Modification to run CPU09CMI on 3MHz bus.

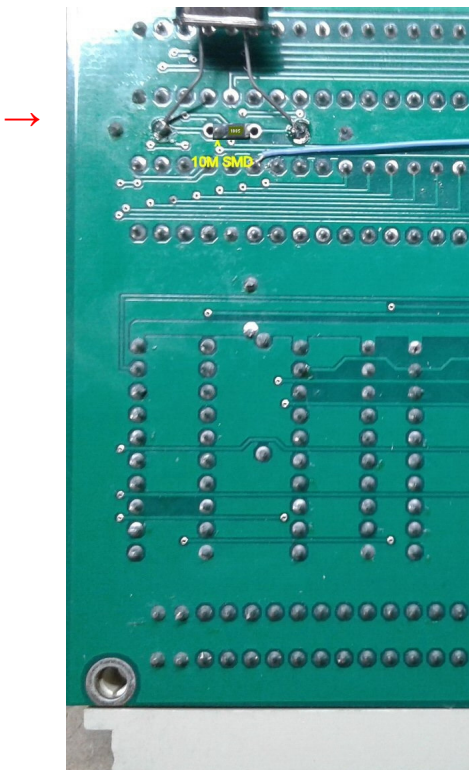
Replace xtal into 12MHz.

Replace C1 and C2 by 18 pF.

Place 10M 1206 smd between crystal pins.

↓ Only 10M 1206 smd between crystal pins.
